Immingham Green Energy Terminal

10.8 Proposed Further Change Application Report

Document Reference: TR030008/EXAM/10.8

Drawing Title
**FURTHER CHANGE
APPLICATION REPORT -
SITE BOUNDARY AND WORKS PLAN CHANGES
FOR PROPOSED CHANGES 5 - 9
SHEET 1 OF 4**

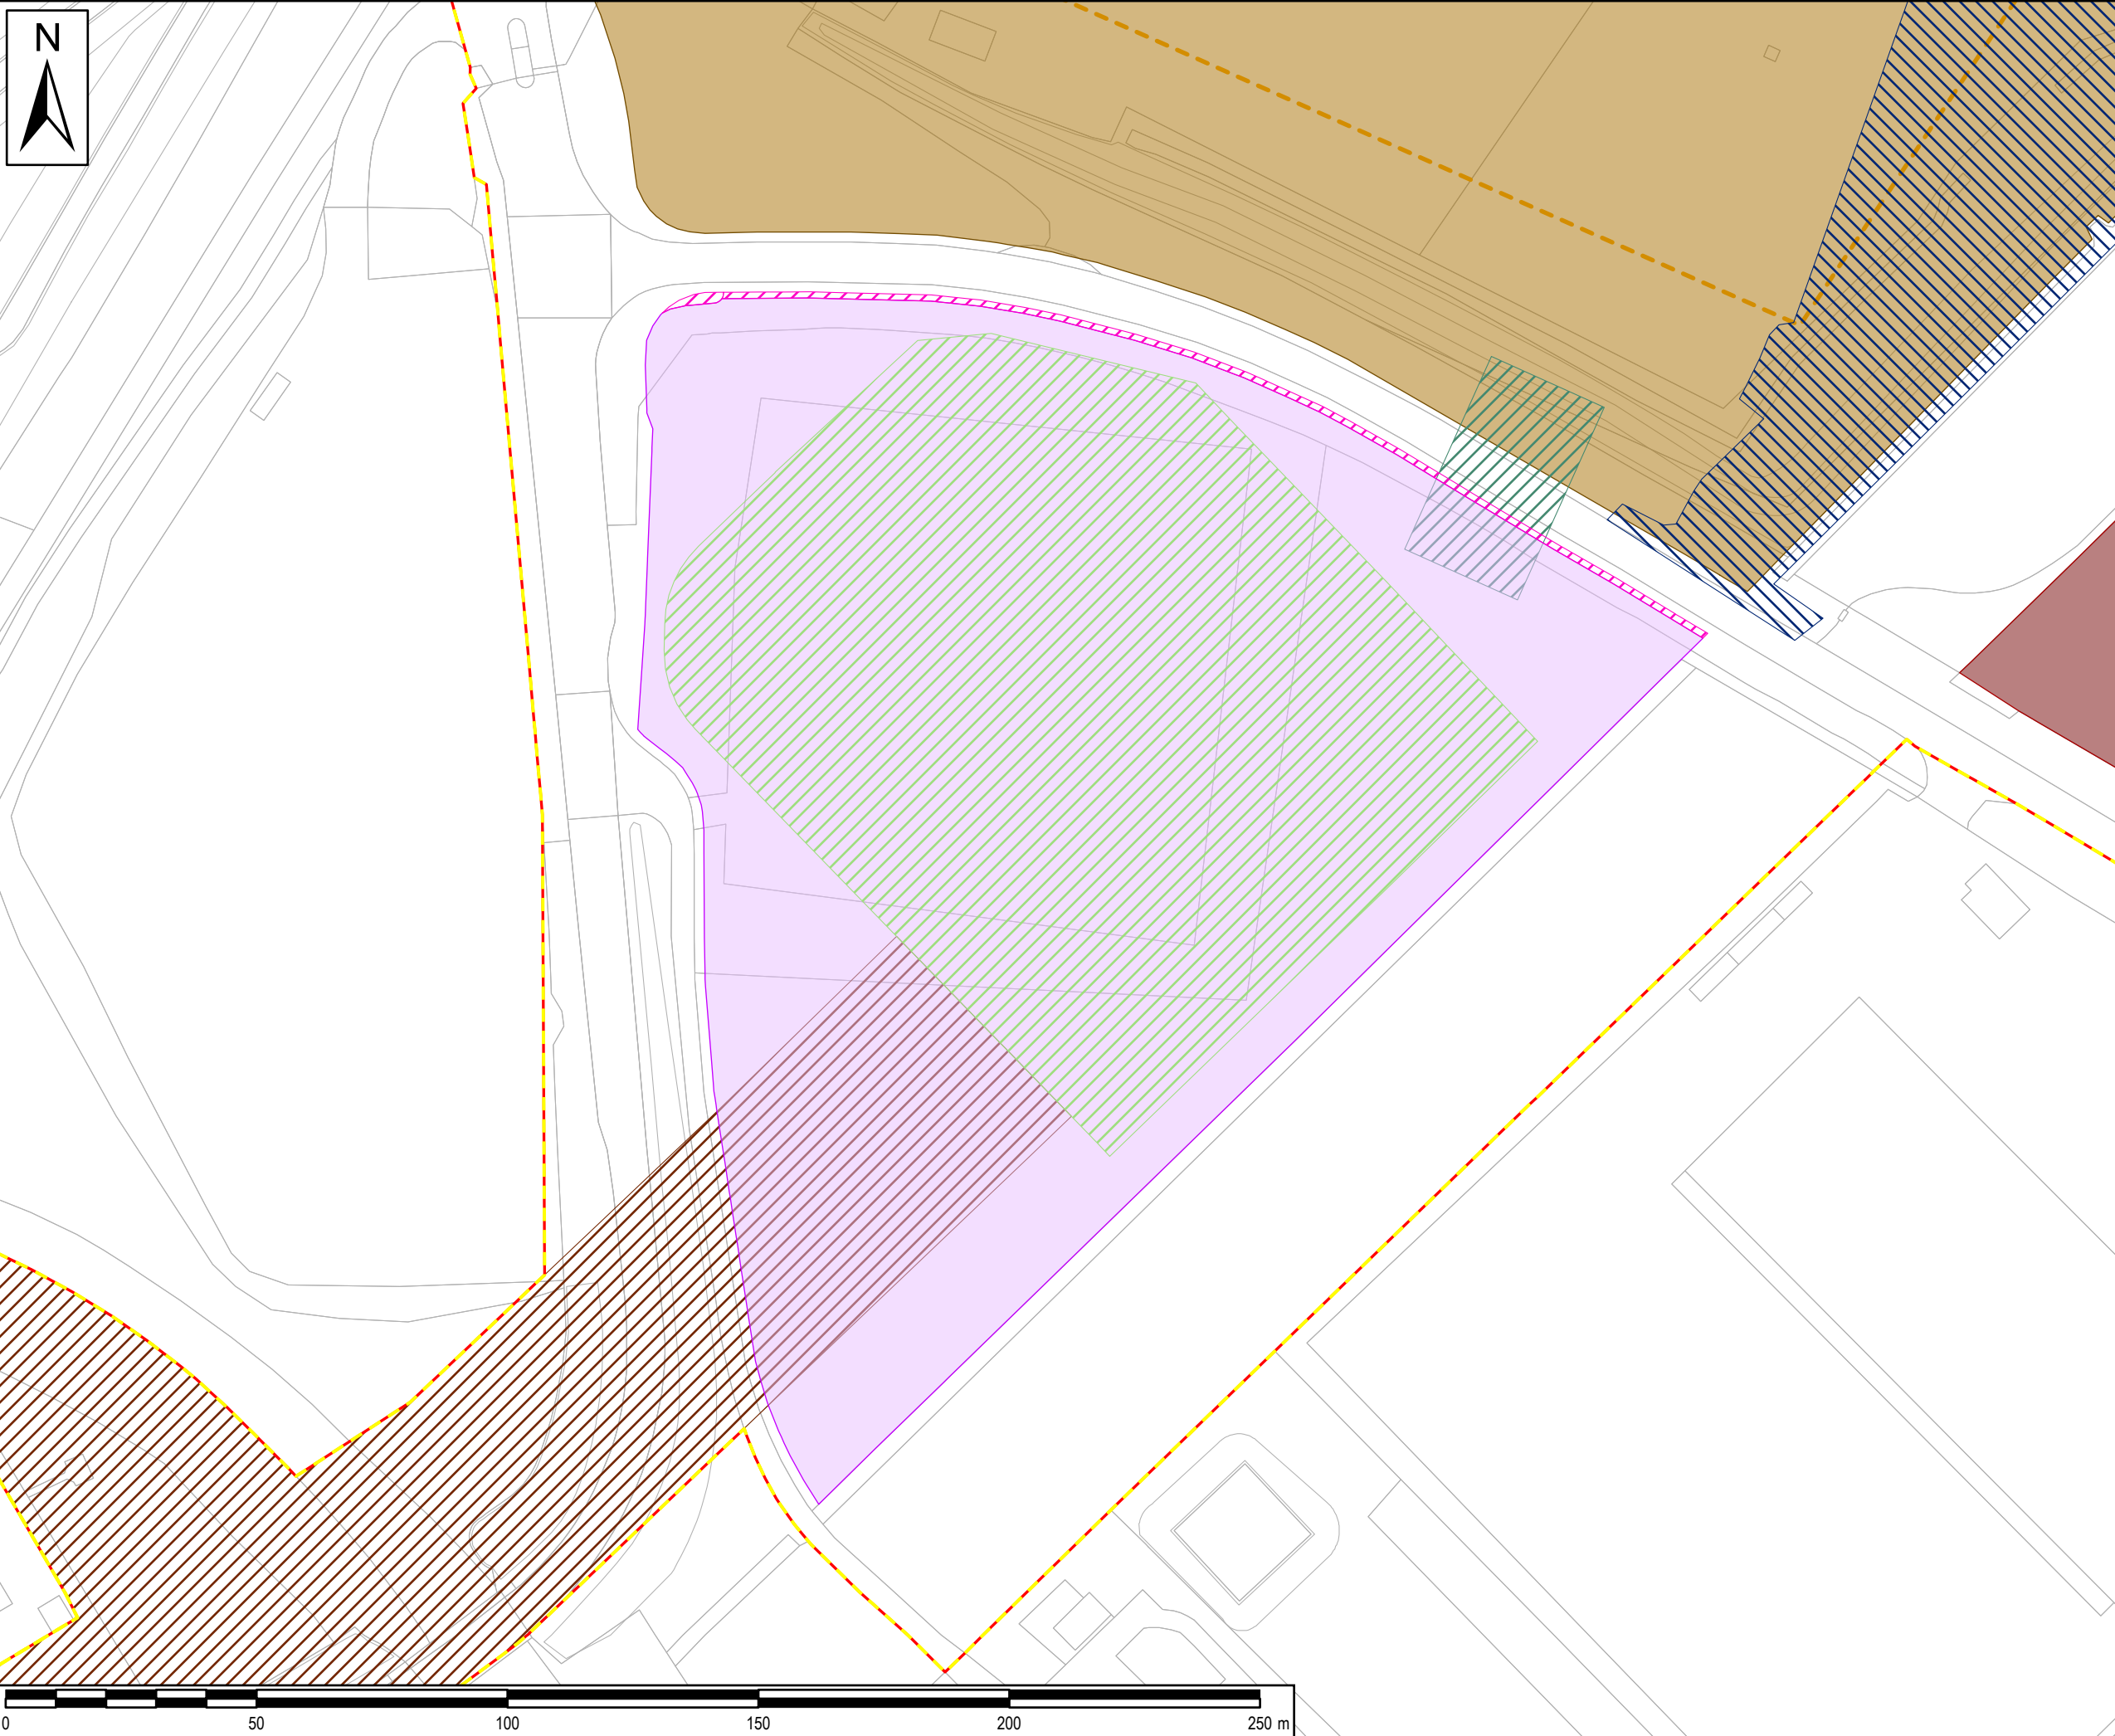
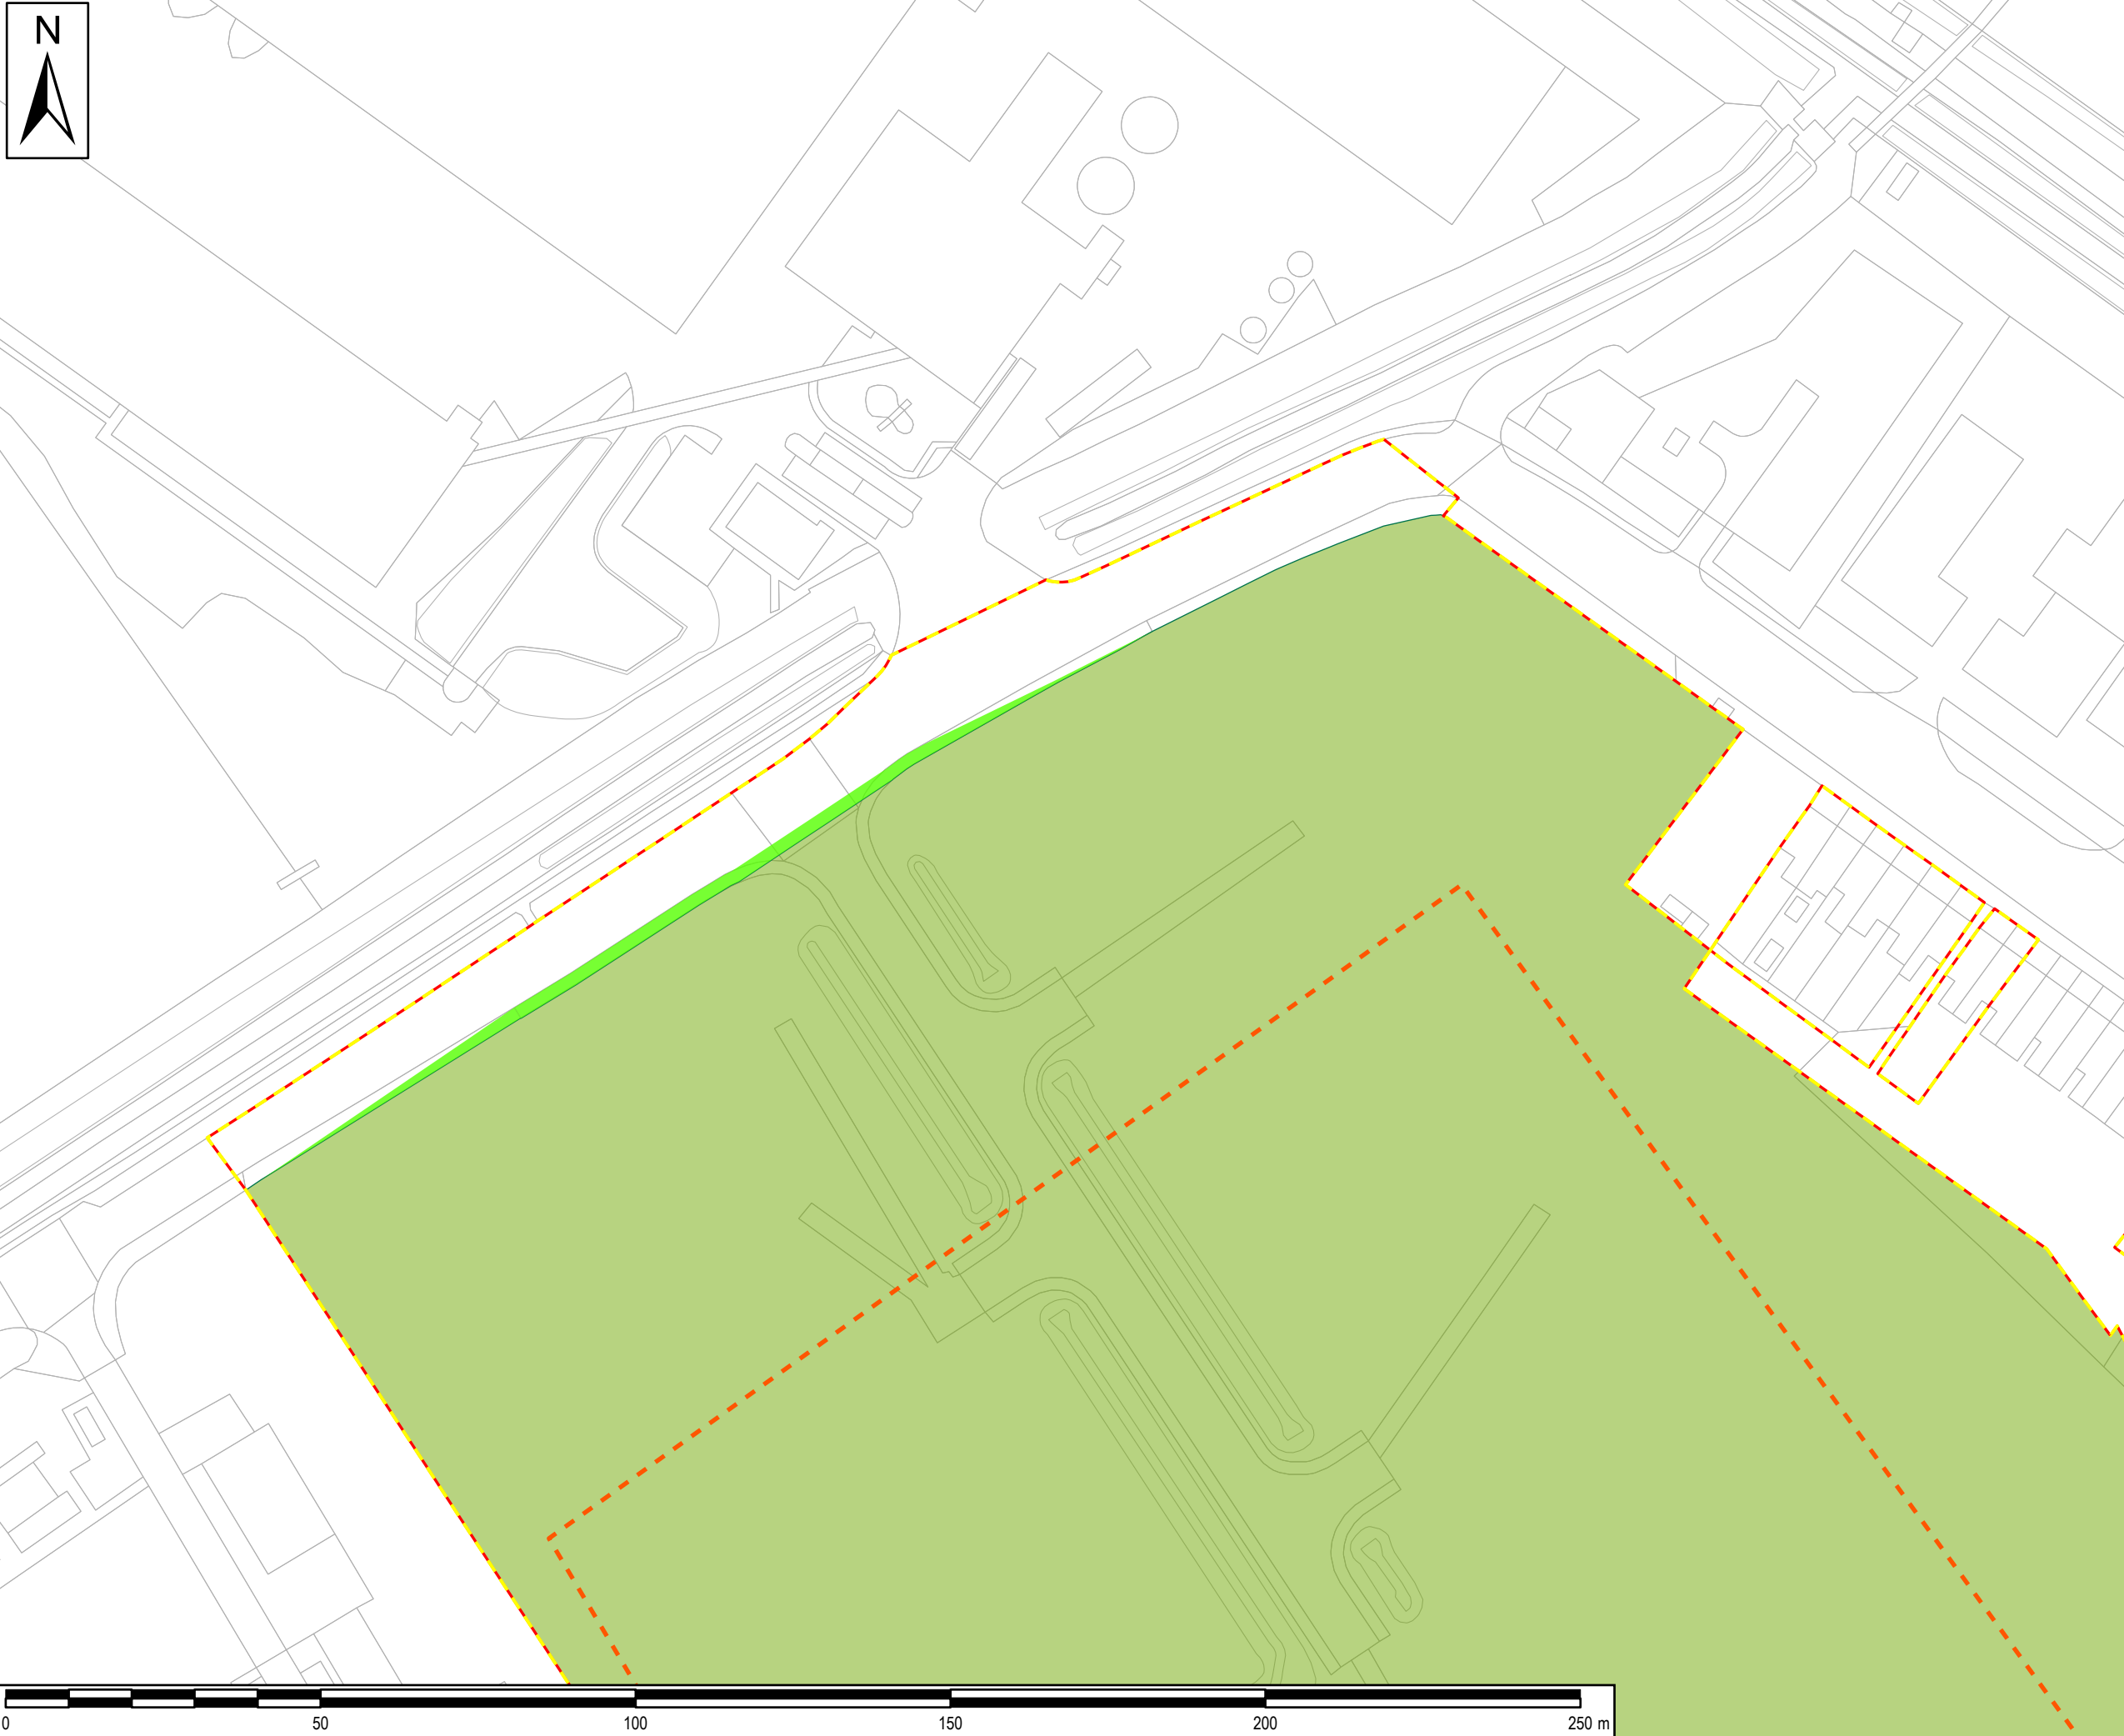
2.6.3 **Appendix 1** illustrates the location of the proposed change and **Appendix 2** illustrates the reduction in the Order limits as a result of the reduction in the area of Work No. 9.

2.6.4 The implementation of this change would result in alterations to the **Works Plans [TR030008/APP/4.2(4)]** and **Land Plans [TR030008/APP/4.5(3)]** (reducing the extent of plots 4/28 and 4/32). It would also involve consequential changes to other Application documents (which have been submitted as part of this Proposed Further Change Application and are listed at **Appendix 12**) as a result of the reduction of the Order limits and extent of temporary possession powers sought.
